MONTICELLO NUCLEAR GENERATING PLANT
Docket No. 50-263 License No. DPR-22

Response to 12/16/77 Request for
Information on HDFSS

RESPONSE TO REQUEST FOR ADDITIONAL
INFORMATION ON MONTICELLO HDFSS SUBMITTAL

FIGURE 2 FIXED-BASE LUMPED-MASS MODULE MODELS IN POOL

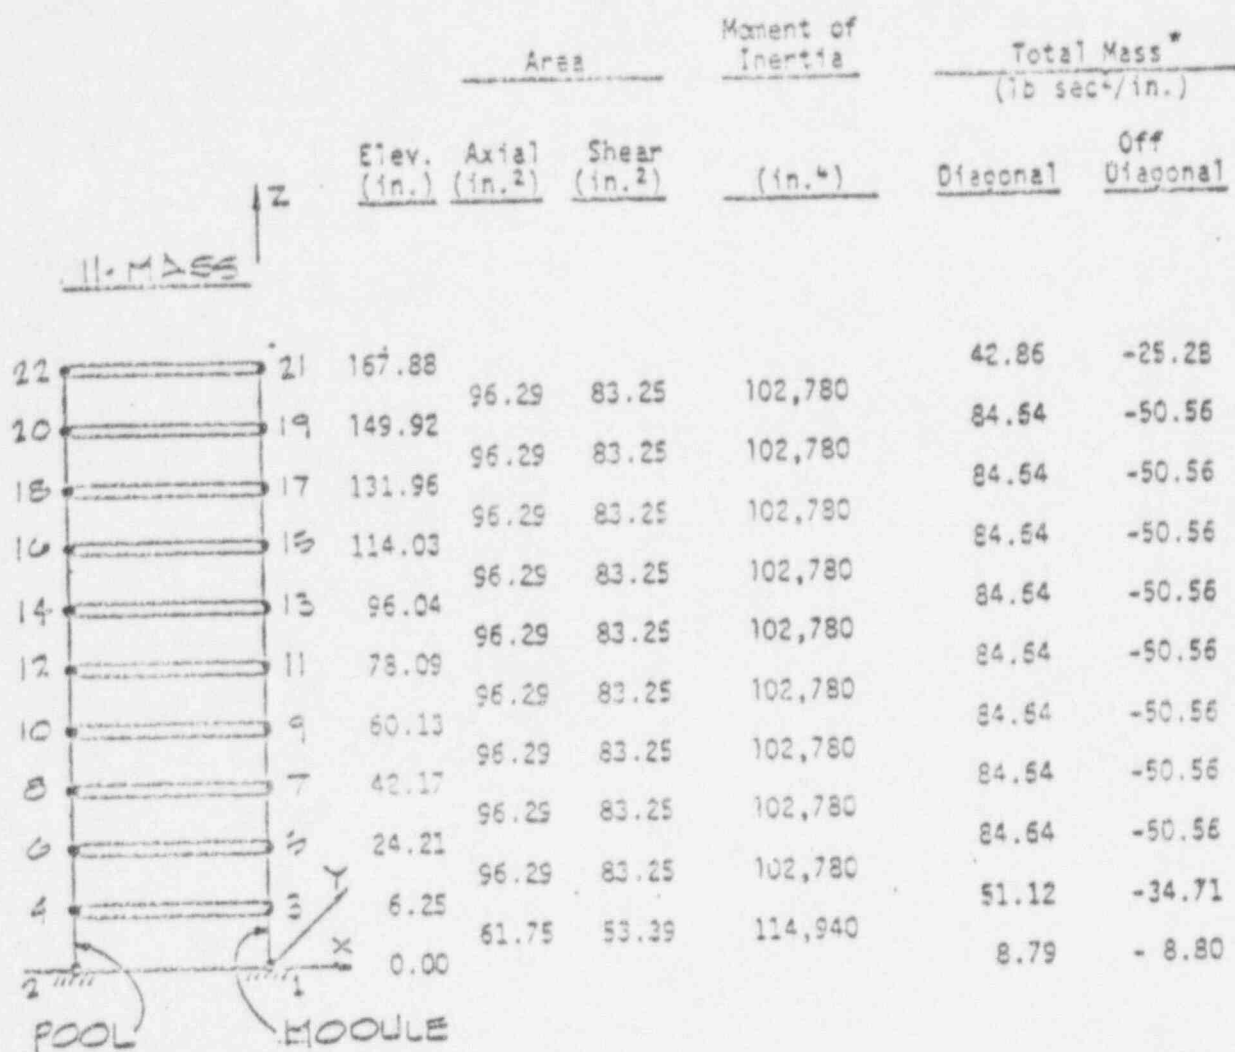
Q-2 Provide sketches and details of the mathematical model used to analyze the rack assembly and fuel pool.

An eleven-node lumped-mass model was then developed by lumping the tributary module mass to the corresponding node point and initially selecting the stiffness properties based on beam theory. The stiffness properties of this model were based on matching the natural frequencies of the lumped-mass model. The natural frequencies of the first seven modes are given in Table 1. The sectional properties are given in Figure 2.

Finally, in order to simplify the subsequent analyses, a less complex model was developed. Since the response of the module and column support system was shown to be primarily a rigid body motion, it was found that a two-node lumped mass model can be used to adequately represent the module and column support system analyses. Both the first mode and rigid body dynamic properties were simulated by this model. The lumped mass at the top of the two-mass model was selected so that the base shear force of the first mode was preserved. The height of the model was selected to preserve the overturning moment at the base of the module for both the first mode response and rigid body motion. The mass of the bottom of the model was set equal to the difference between the total module mass and the mass at the top. This ensured that the shear force at the base was preserved for rigid body motion. Finally, the stiffness of the structural element was selected

to preserve the fundamental frequency of the module. The properties of the two-node lumped-mass model are shown in Figures 2 and 3.
